Memorandum

Subject: Response to Testimony Related to Stormwater and Groundwater

Project #s: PWB: W02563 BC: 152606

Date: May 5, 2025

JOHNSON CREEK UPPER WATERSHED

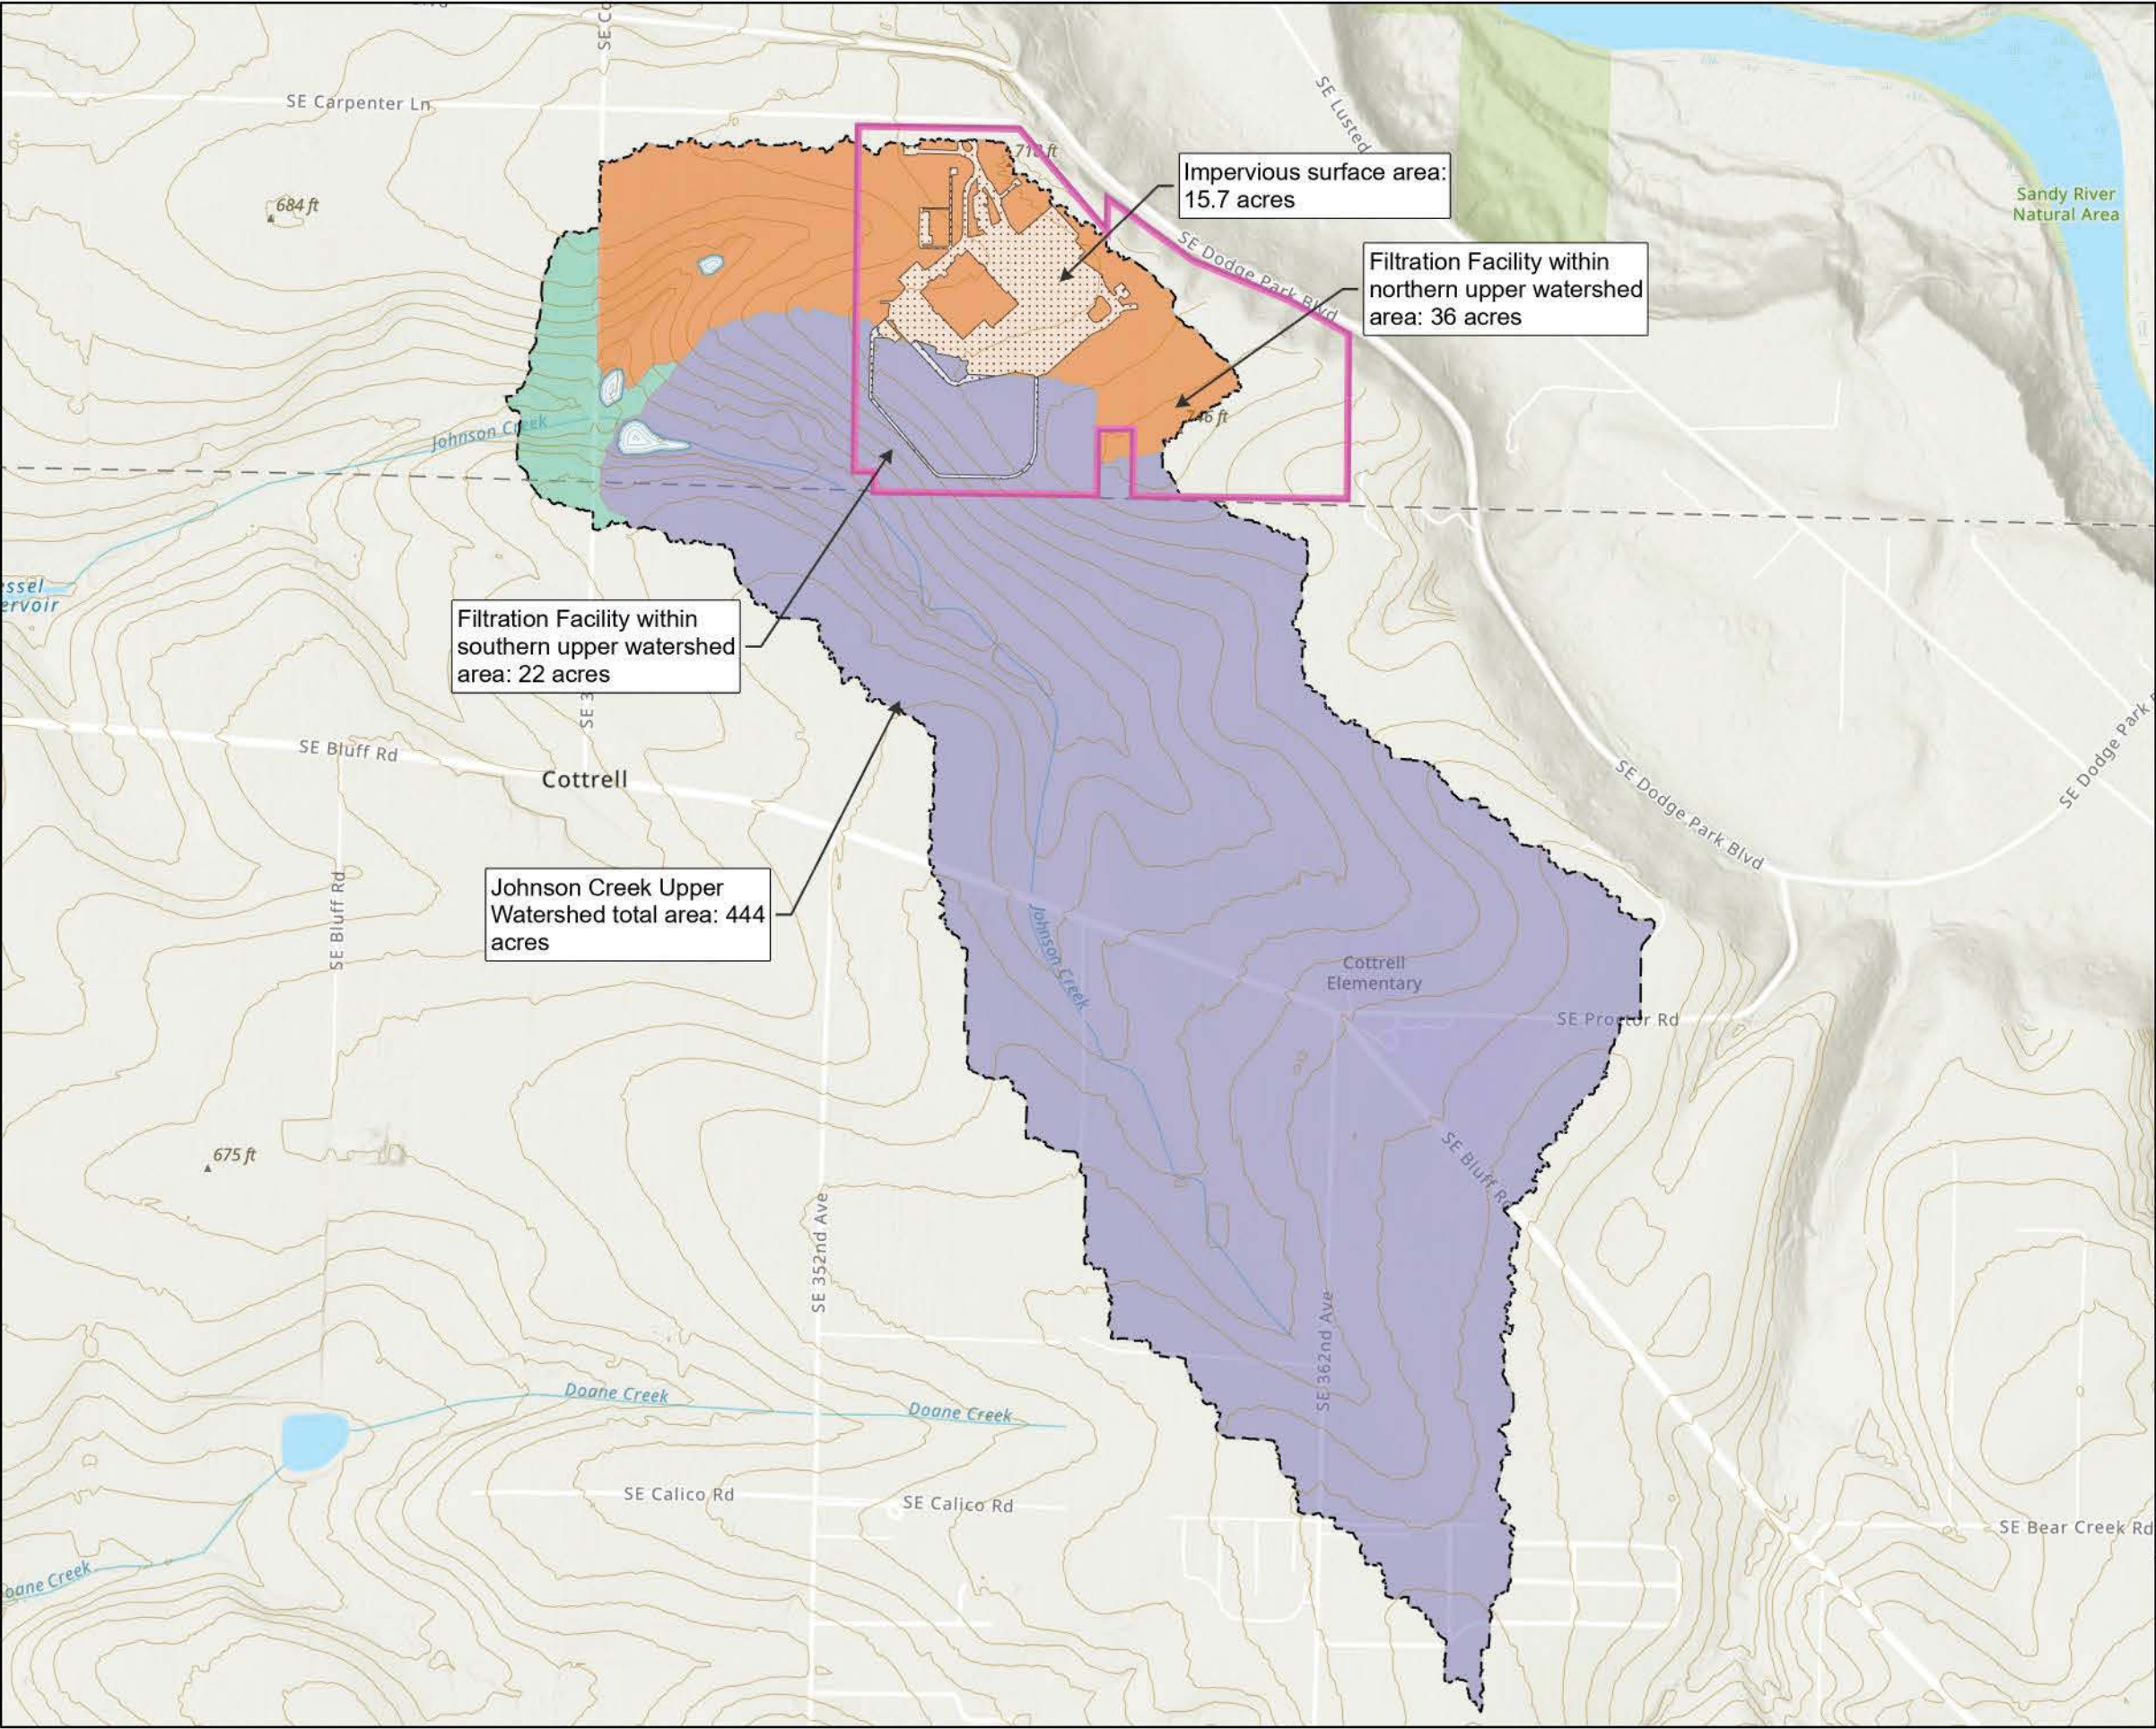
“Large, paved surfaces, such as the facility proposed at the headwaters of Johnson Creek”

As shown on the attached *Johnson Creek Watershed Figure*, the impervious surface of the Filtration Facility in post construction represents only about 3.5% of the area that feeds the reach of Johnson Creek adjacent to the Filtration Facility site.
